Department of Energy
Richland Operations Office
P.O. Box 550
Richland, Washington 99352

BWIP HYDROGEOLOGIC AND WASTE PACKAGE INFORMATION DATA PACKAGE

The enclosed information package covering hydrogeology and waste package was informally transmitted to DOE-RL by H. J. Miller-NRC on November 23, 1982. These documents had been provided to NRC as uncleared information during DOE/NRC workshops held in July and August 1982 covering these subjects.

BOREHOLE REVIEW FORM

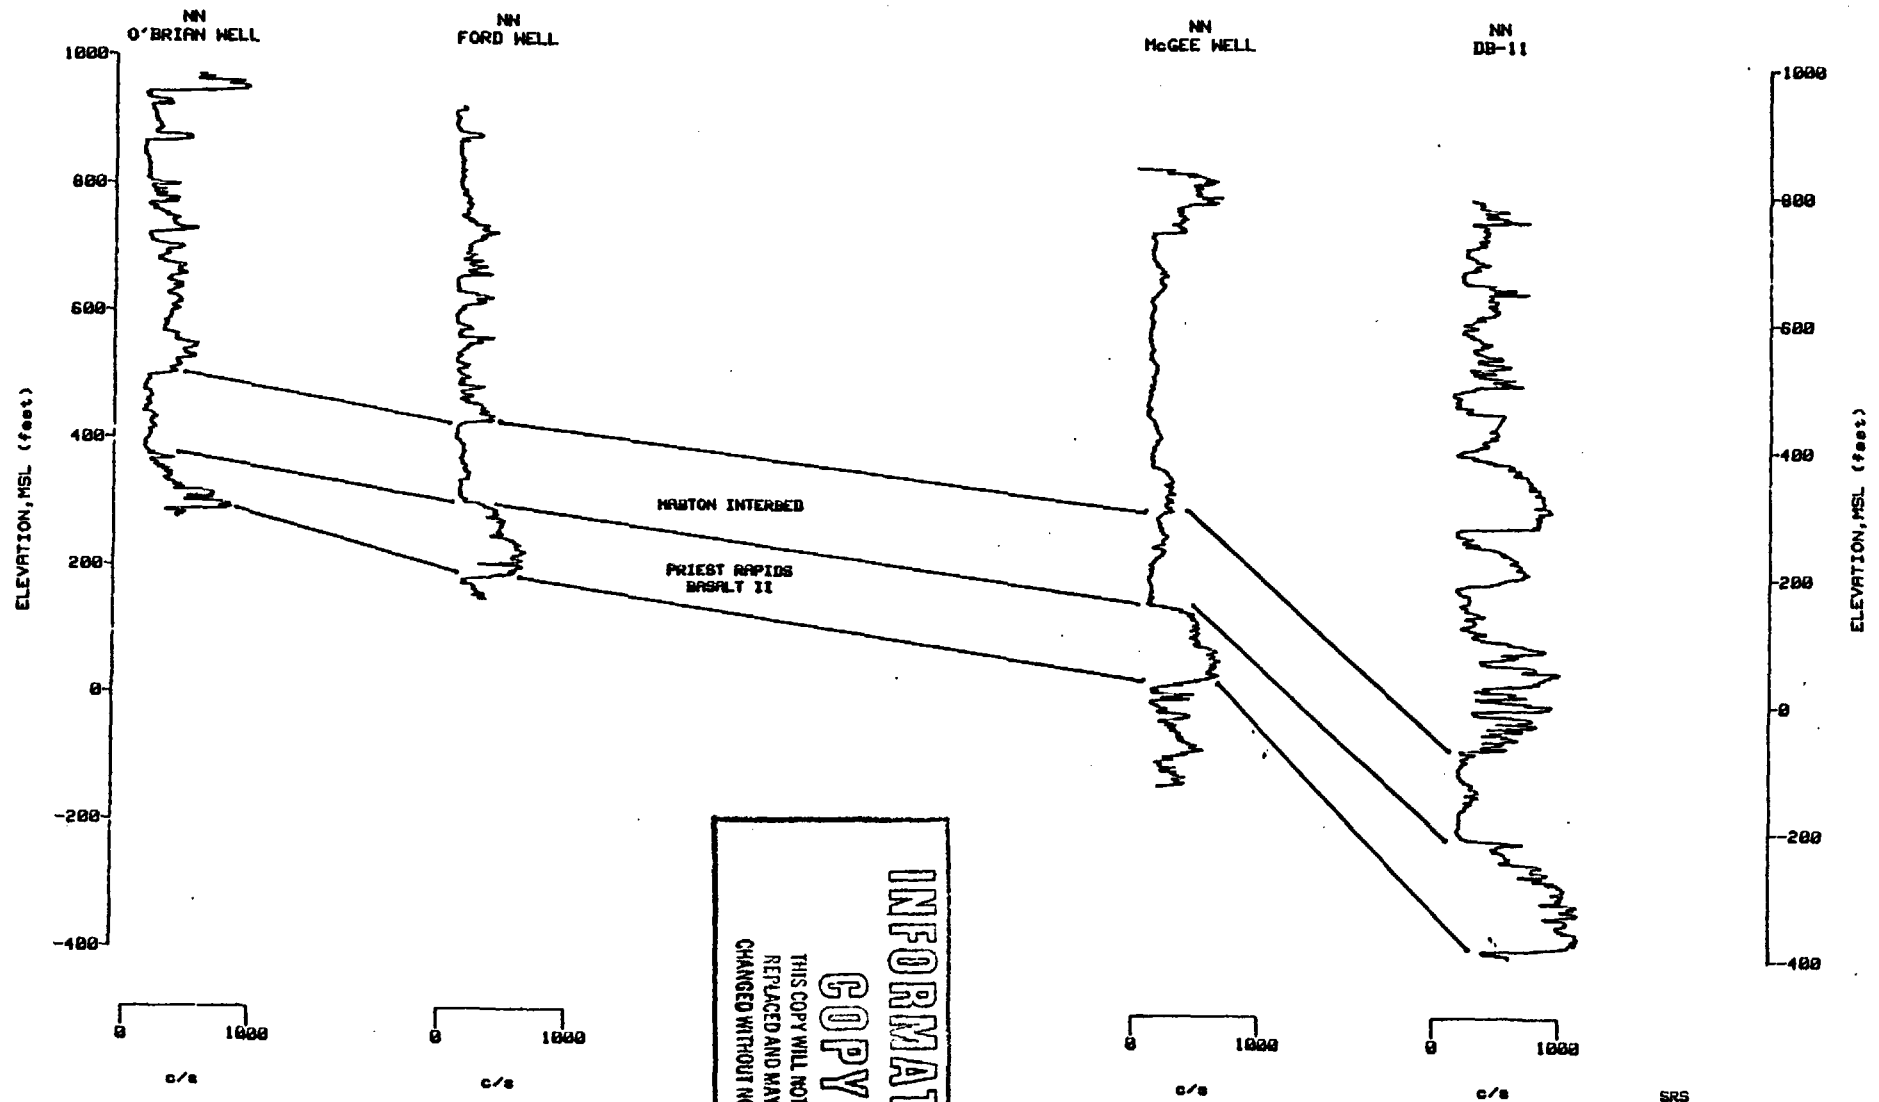
logs were not very straight -
note attached sheet.

HYDROGRAPH FOR WELL LOCATION HANFORD SITE-

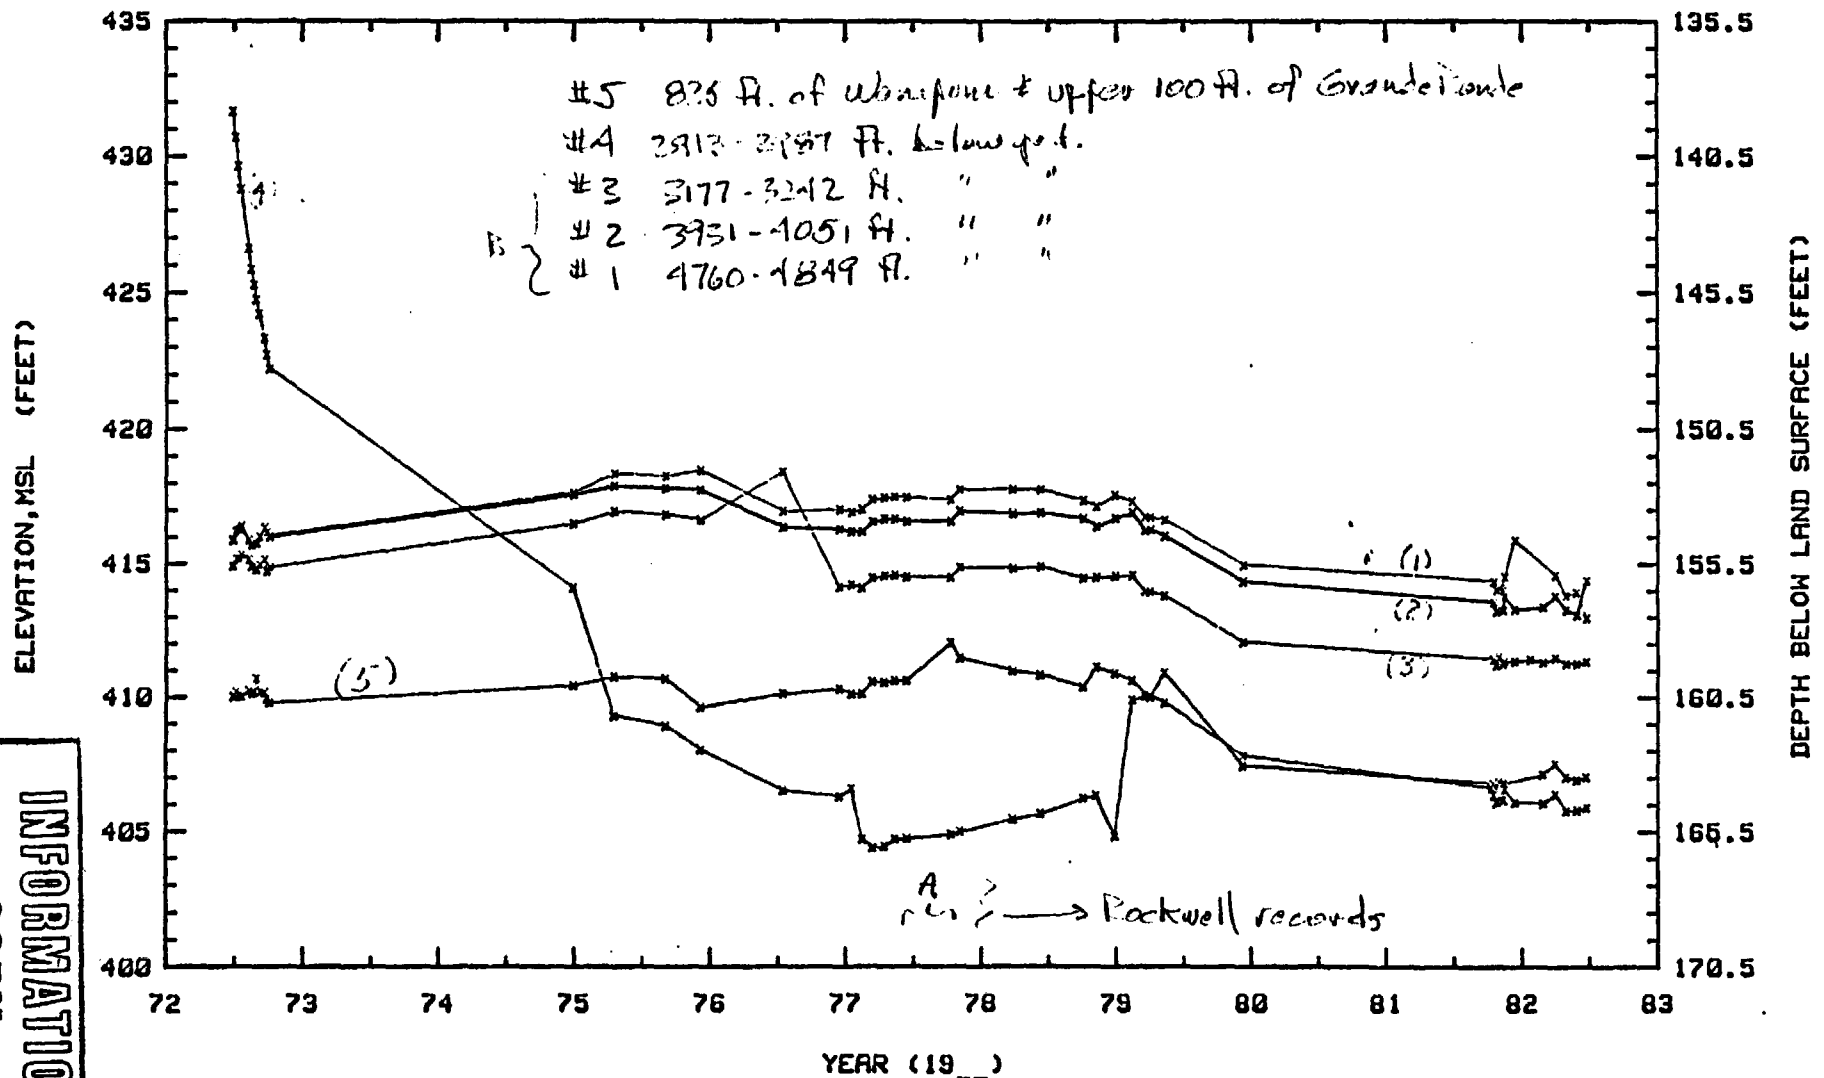
B - Rockwell points out possibility that leakage exists in hole between piezometers; - over-
